Application no: R3.0138/21

Transport Development Control

Recommendation:

Oxfordshire County Council (OCC), as the Local Highway Authority is currently recommending a holding objection to this planning application subject to the following:

Figure 2.3.3: OFF3 Available Stages

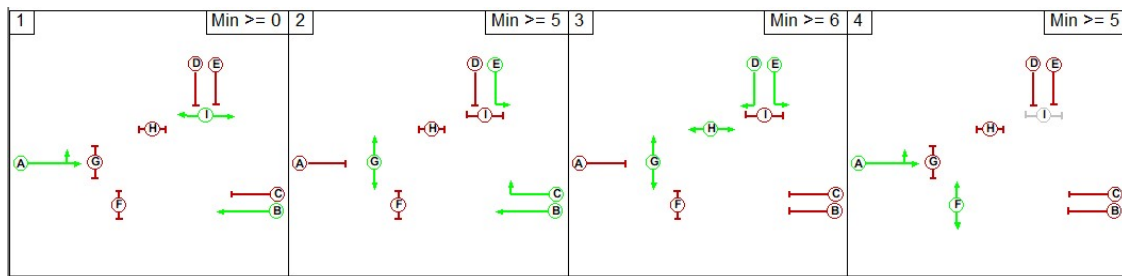
The modelled sequence was 1-2-3-4. This would be the most robust sequence, as it assumed that Phase F is called every cycle (Stage 4). However, if Phase F demand was expected to be low, then the model would provide unrealistically pessimistic results due to a significant reduction to westbound traffic (i.e., if Stage 4 were not demanded, the junction would move to Stage 1 and provide green to Phase B).

Figure 2.6.4: OFF6&7 Model versus Specification Intergreens

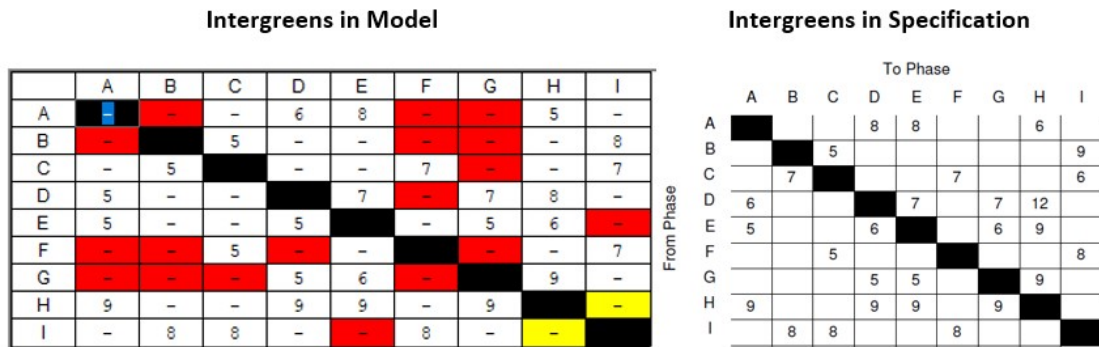
- 2.6.11 Many of the intergreens used in the model were lower than those within the controller specification. A comparison between them is shown in **Figure 2.6.4**.

Figure 2.15.3: SCH2 Available Stages

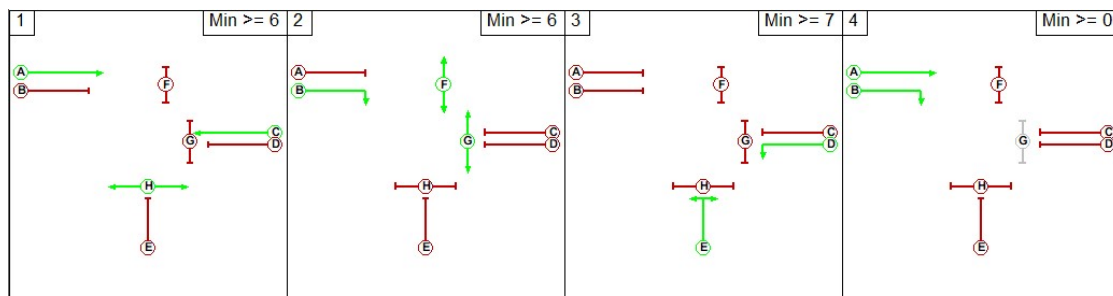
- 2.15.4 The Valley Park Access nearside lane was set as a flare, length 7 pcus. JCT assume this was correct, as the provided drawing did not show far enough upstream of the stopline to check this.
- 2.15.5 All pedestrian phase minimum times were set to 6 seconds. These will depend on the types of pedestrian facilities installed. If far-sided green man displays are used, then longer minimum times may be required on the longest crossings (up to 9 seconds across Valley Park), unless countdown timers are also used. If near-sided displays are used, then 6 seconds may be acceptable. However, this should not make a significant difference to the modelling results.
- 2.15.6 The stages used in the model are shown in **Figure 2.15.3**.

The modelled sequence was 1-2-3 (i.e., assuming Phase F was called). Stage 4 would be an alternative to Stage 2, when there is no demand for Phase F.

Figure 2.15.4: SCH2 Intergreen Comparison

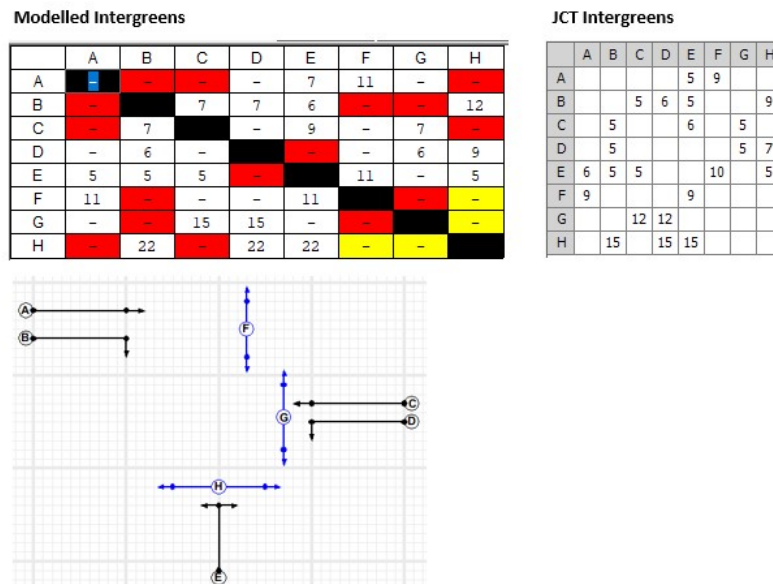
- 2.15.7 JCT measured the intergreens using quickGreen, based on guidance in Chapter 6 of the Traffic Signs Manual. The full quickGreen output is included in Appendix B. **Many of the intergreens used in the model were significantly higher than those measured by JCT.** The reason for this was unknown, but could result in the model predicting less capacity than would be expected. A comparison of the intergreens is shown in **Figure 2.15.4**.

- 2.15.8 The model contains several very long phase delays. It is unclear why these were used, but likely to reduce lost time created by long pedestrian intergreens. However, the length of delay does not correspond with the long pedestrian intergreen. A significantly long phase delay of 11 seconds was given to Phase D from Stage 3 to 1, without any pedestrian intergreens running in that stage. These long phase delays result in significantly long interstage periods up to 24 seconds. These are likely to be undesirable, especially off peak as they will result in much longer green times than necessary.
